To:	All Bidders
From:	Sandra Lovaas, Measure C Bond Manager Pleasant Valley School District
Subject:	Addendum 3, Bid FB-25-04, Pavement Rehabilitation Project, Dos Caminos Elementary School

Bid FB-25-04, Pavement Rehabilitation Project, Dos Caminos Elementary School Revised Addendum 3

TO:	Pleasant Valley School District
ATTN:	Sandra Lovaas
SUBJECT:	Dos Caminos ES Bid FB-25-04
WORK ORDER:	1002
DATE:	April 1, 2025

ADDENDUM NO. 3

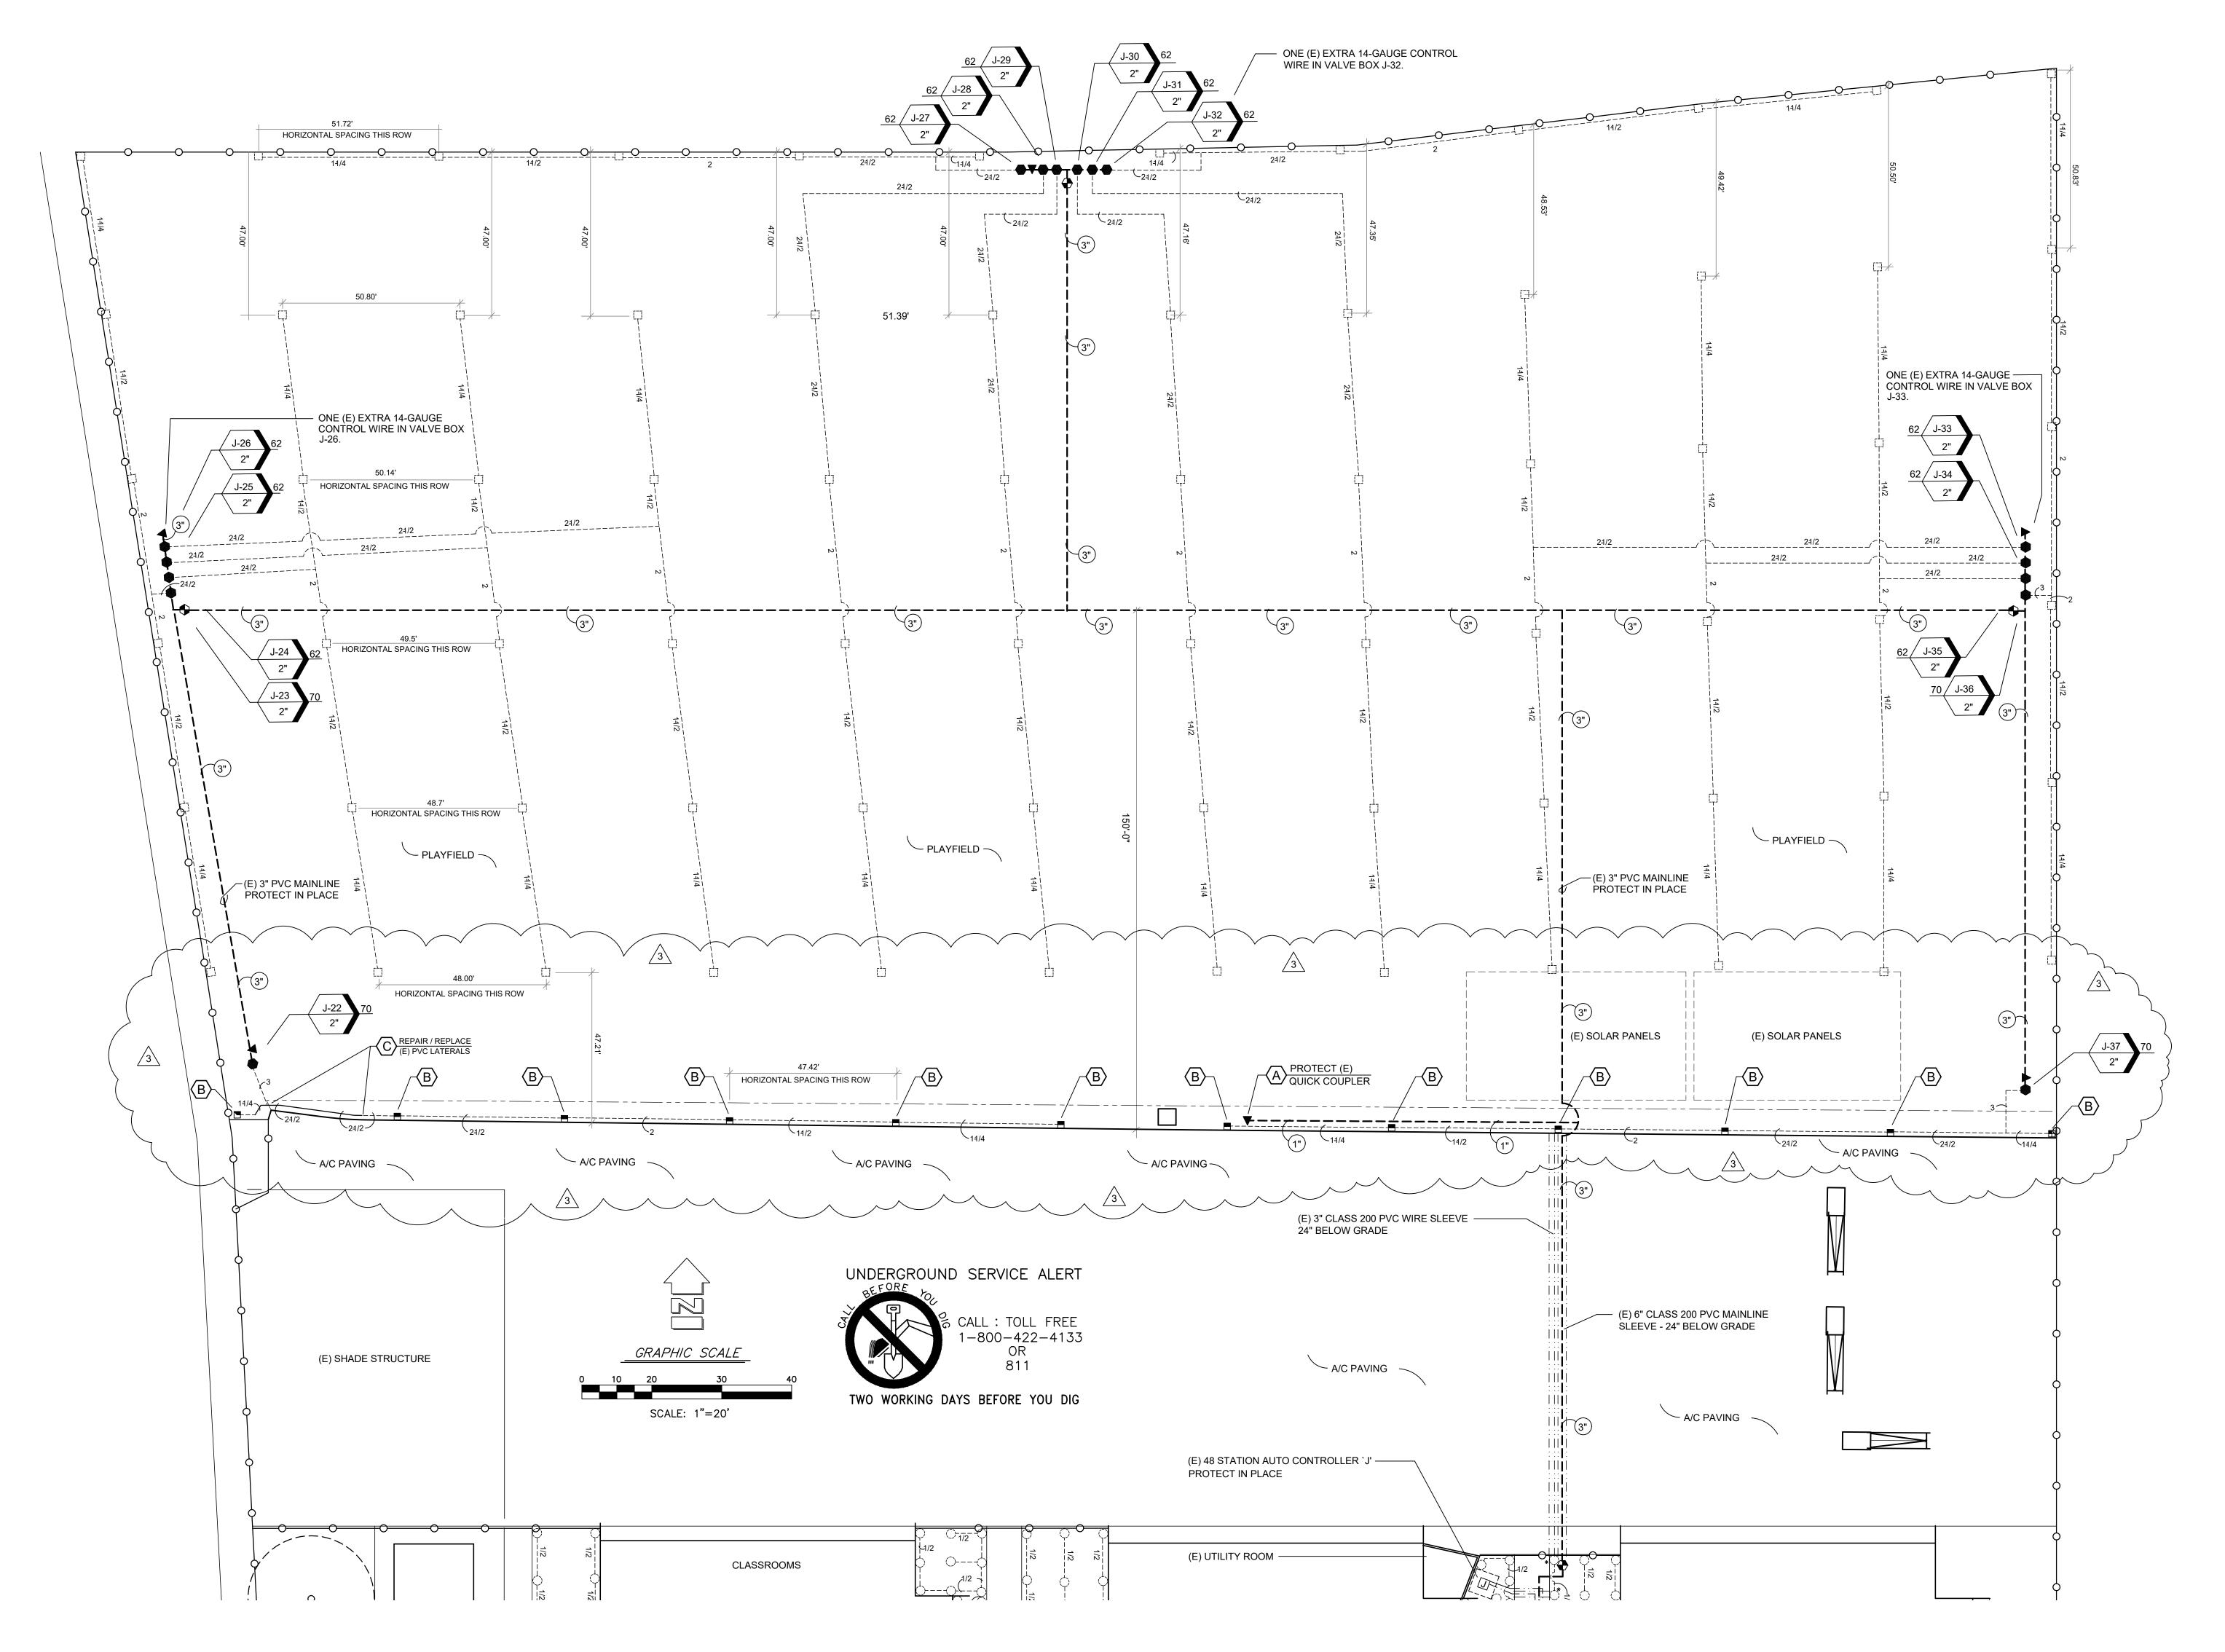
- A. Sheet L1.1 Irrigation Plan
 - 1. Key Note 'A'- Description of Scope of Work has changed:
 - a) Delete "The addition of new 1" Schedule 40 PVC irrigation mainline and 1" quick coupler".

- 2. Key Note 'B'- Description of Scope of Work has changed:
 - a) Delete "Install new pop-up turf lawn rotors with new buried PVC laterals adjacent to proposed concrete drainage swale". The concrete swale has been removed from scope of work".

- 3. Key Note 'C' Description of Scope of Work has changed:
 - a) Delete All work associated with relocating the existing full circle turf rotors. Protect the existing full circle turf rotors in place.

- B. Sheet L1.2 Irrigation Legend
 - 1. Irrigation Key Notes have been changed as follows:
 - a) <u>EXISTING QUICK COUPLER IN A 10" ROUND VALVE BOX PROTECT IN</u> <u>PLACE</u>: Field verify the exact location of a 1" quick coupler installed in a 10" round plastic valve box. Protect quick coupler assembly and valve box from damage due to new fine grading work. Excavate areas around valve box and 1" quick coupler on swing joint assembly. Reset valve box and quick coupler so that the quick coupler has a 3" minimum clearance between top of quick coupler lid and bottom of valve box lid. Valve box shall be positioned so that is flush with new finish grade surface. Compact soil around valve box to prevent any settling.

- b) PROTECT IN PLACE (E) BURIED PVC ROTOR LATERALS INSTALLED ADJACENT TO THE NEW ASPHALT PAVING - REPLACE (E) I-40 PART CIRCLE ROTORS AND 1" SWING JOINTS - ADJUST TO NEW FINISH GRADE ELEVATIONS: Field verify the exact location of the part circle pop up turf Hunter i-40 rotors installed adjacent to the asphalt. Flag their locations. Complete new fine grading paving operations as per Civil Engineer's plans. Excavate and expose the (E) turf rotor and swing joint assembly. Remove (E) 1" swing joint and part circle rotor. Replace 1" swing joint and install a new i-40 part circle pop up turf rotor. Set new i-40 pop up rotor to be flush with new finish grade. Adjust arc pattern to ensure that irrigation water does not over spray onto new asphalt paving. The intent of this work is to salvage and reuse the (E) buried PVC laterals along the edge of the asphalt paving. If the (E) buried PVC rotor lateral is damaged or destroyed during grading operations, replace and/or repair with new matching sized Sch. 40 PVC lateral and fittings. For base bid purposes, expect to replace a total of (12) i-40 part circle turf rotors with new 1" swing joints as part of the new work.

- c) <u>REPAIR EXISTING SCH. 40 PVC TURF ROTOR LATERALS AS A RESULT OF</u> <u>NEW CONSTRUCTION WORK</u>: The construction of the new asphalt pavement will damage the existing pop up turf rotor laterals. Field verify the exact location of the PVC laterals prior to the installation of the new drains. Excavate and expose the pipe so that it can be cleanly cut to protect as much of the existing lateral in place. Field verify the exact pipe size that will be impacted by the new work. Replace the damage pipe sections with same size Sch. 40 PVC lateral and fittings and route piping around the new drains. Reconnect piping to re-establish the water supply to all existing turf rotors. Be sure to prevent soil from entering the new and existing piping during the repair efforts.

- b) Add "Protect existing 1" PVC mainline and quick coupler in valve box in place. After finish grading work has been completed, excavate around existing valve box and quick coupler assembly. Readjust 1" quick coupler swing joint to allow top of quick coupler to have a minimum clearance of 3" from valve box lid. Valve box to be positioned so that it is flush with new finish grade".

- b) Add "Protect in place existing buried PVC laterals connected to existing pop up turf rotors adjacent to edge of asphalt paving. Operate irrigation system and flag location of existing part circle pop up I-40 turf rotors. Fine grade for soil swale and install new asphalt paving as per civil engineer's plans. Excavate and remove both existing pop-up rotor bodies and remove existing 1" swing joint assembly from existing lateral. Replace with new 1" swing joint assembly and new part circle rotor. Provide any additional fittings needed to position new Hunter I-40 pop up turf rotor along edge of new asphalt paving. Adjust arc rotation to prevent any over spray from contacting new asphalt pavement or fencing.

- b) Add The new asphalt paving work has been modified at the north-west corner of the paved area. The existing buried PVC turf laterals will be damaged due to new construction work. Replace damaged Schedule 40 PVC lateral piping with new size matching Schedule 40 PVC piping and fittings to maintain the historical water supply to the existing irrigation system.

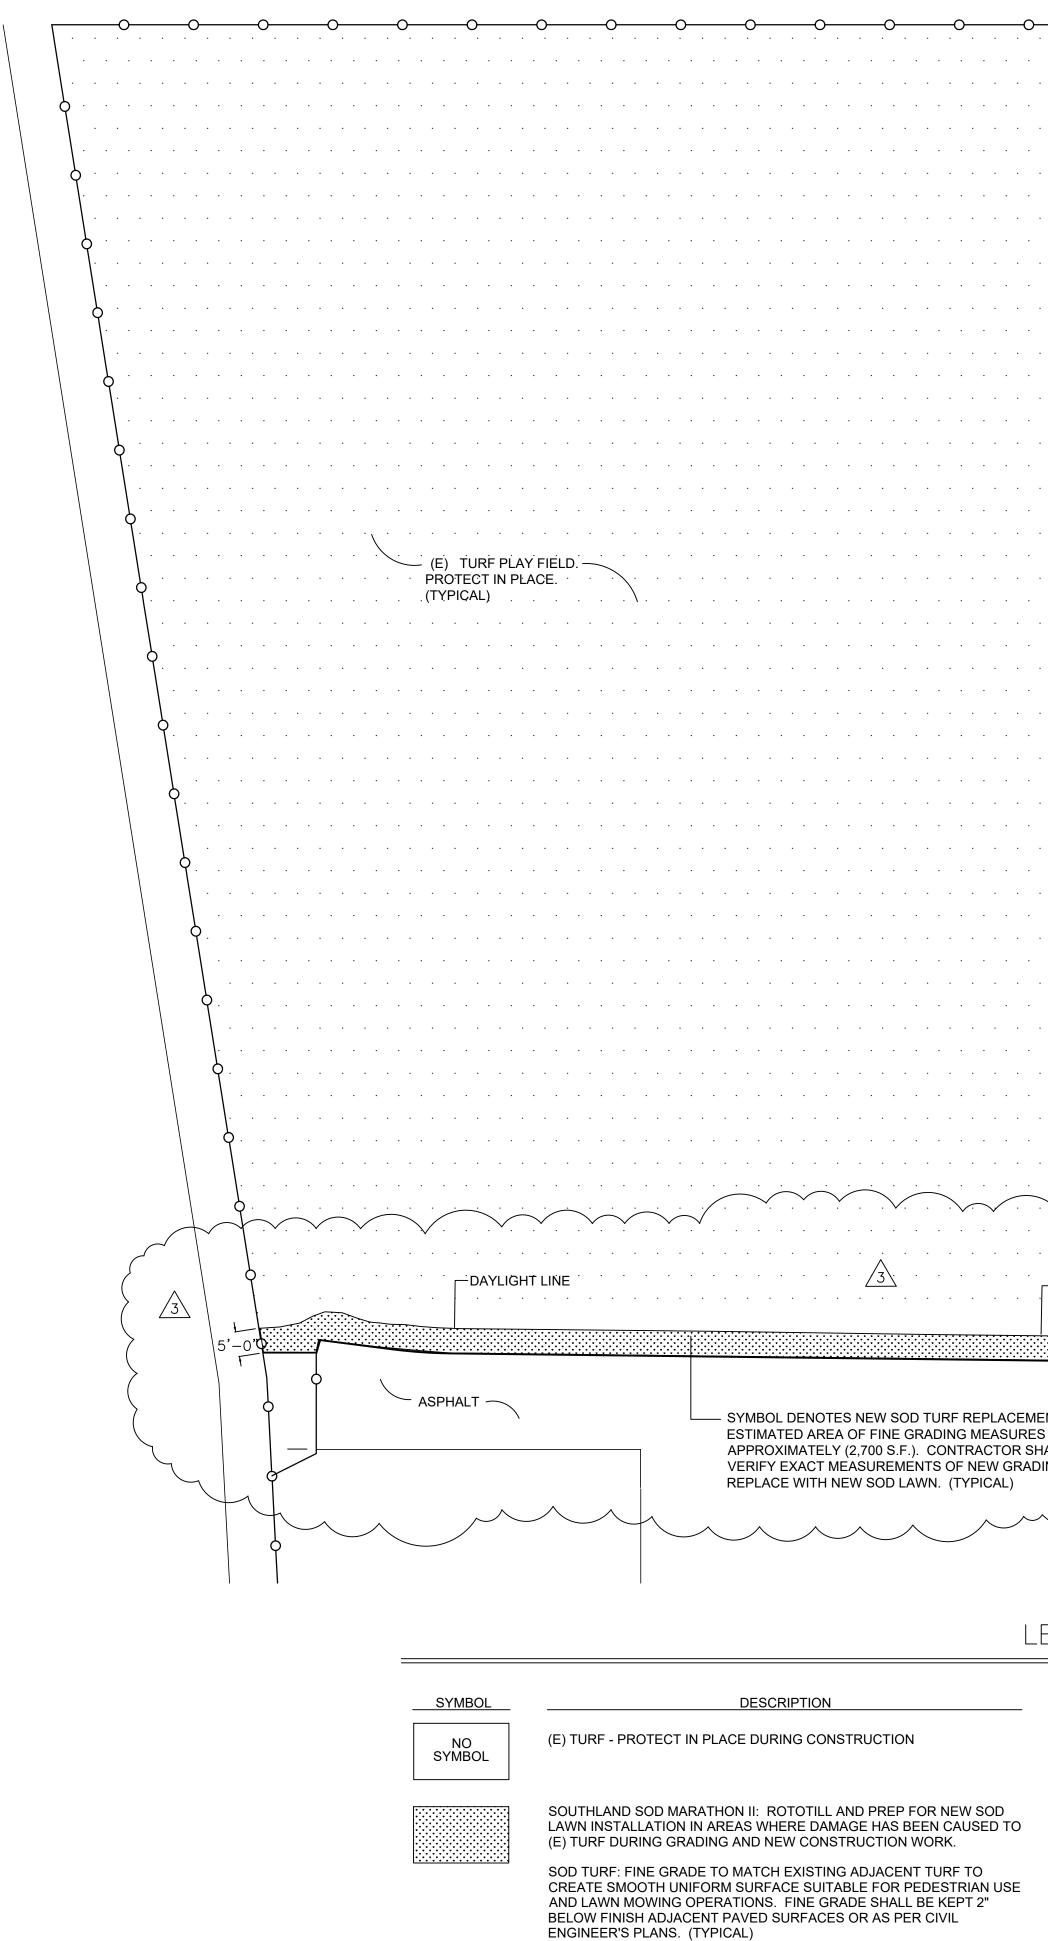
- C. Sheet L2.1 Planting Plan
 - 1. The originally designed 3'-0" wide concrete swale has been deleted. However, a substitute fine graded earth swale has replaced the concrete swale. An estimated 5'-0" wide amount of existing turf will be damaged or destroyed as a result of this new work. Replace with new sod as per plans and specifications. The original estimate of 2,625 sq. ft. of replacement sod remains unchanged. The estimated damaged sod has simply moved 3'-0" closer to the new asphalt pavement edge.
